434-C-1
331 Veranda St.
DK & Landscaping
Martin's Point

RE: Martin's Point Restoration Plan

SUBJECT: Martin's Point Restoration and Drainage Plan

date	number of pages/number of copies/description
9/6/00	1"=20' plan - proposed revision to layout and grading

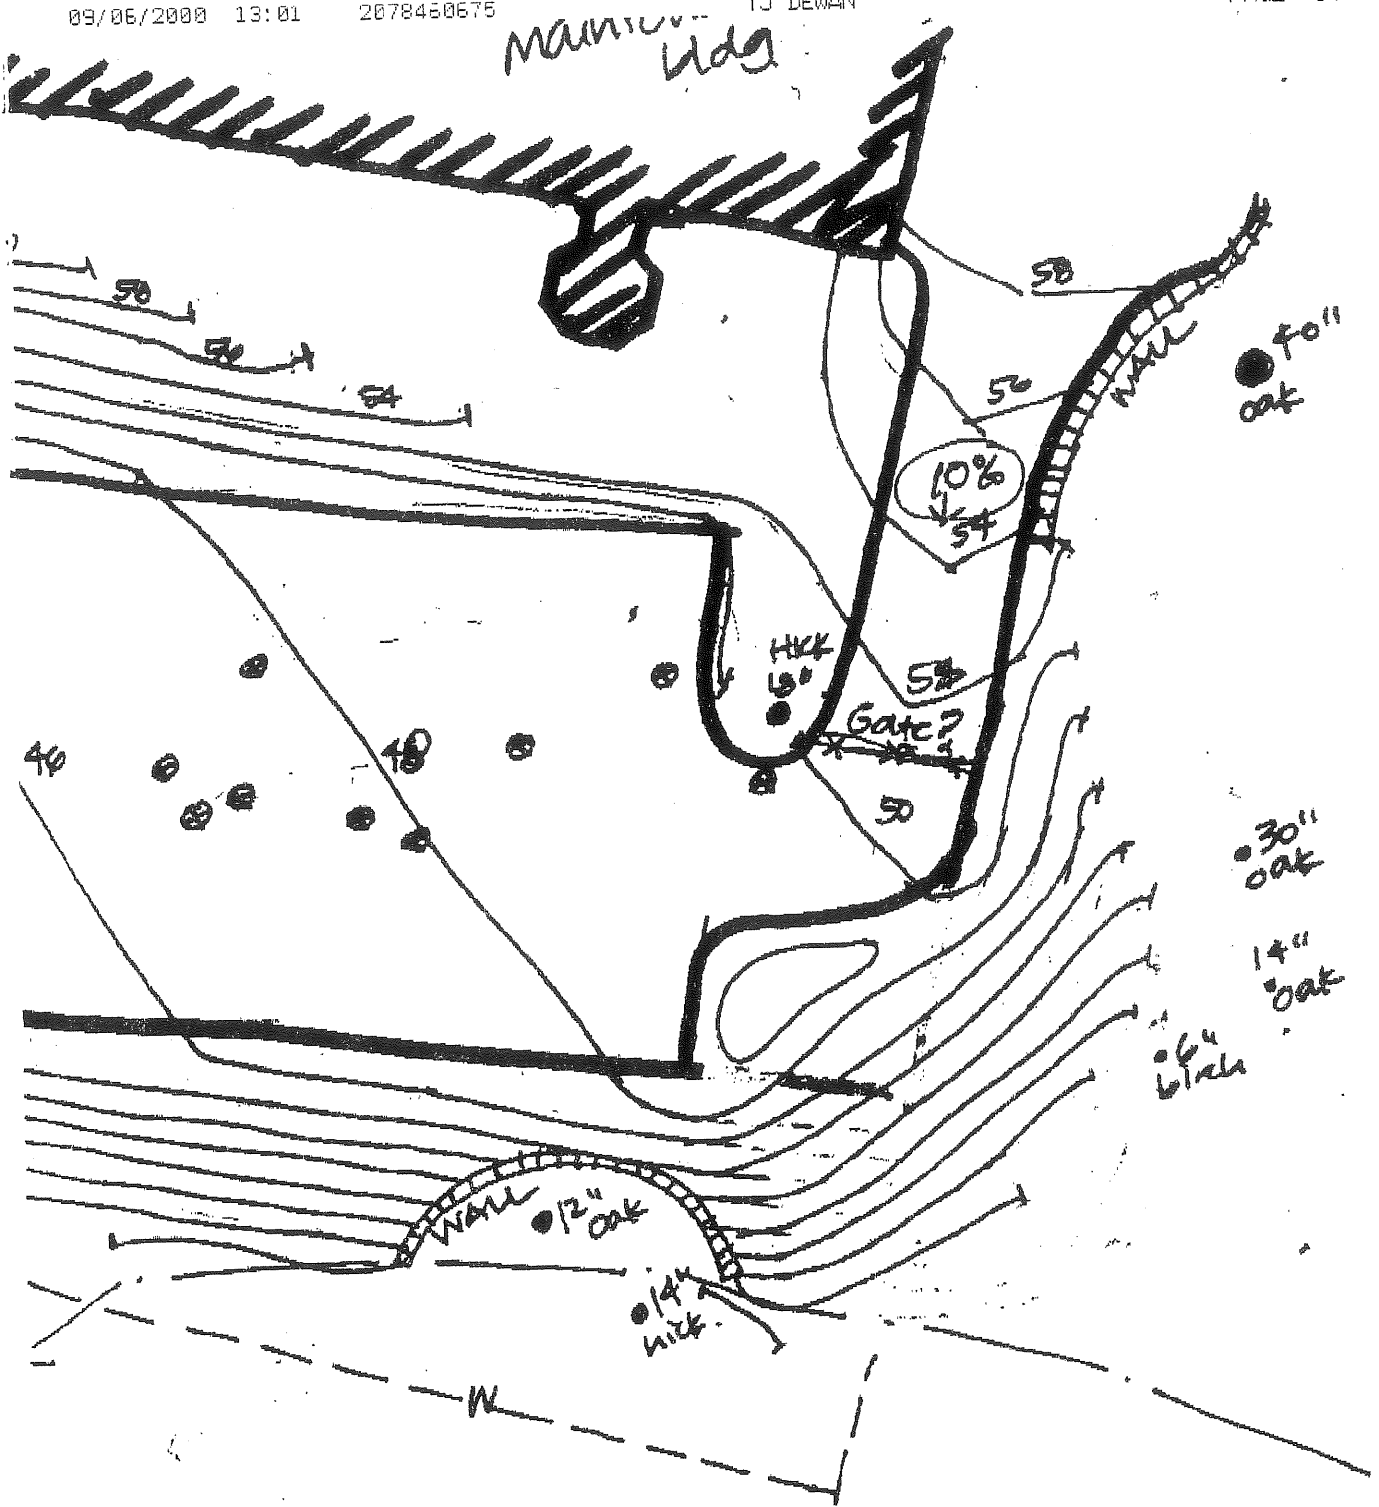
notes: 1) lower parking lot to minimize
 impact of grading, 2) add tree
 wells at critical areas
 3) avoid propane tanks and pole
 re-location
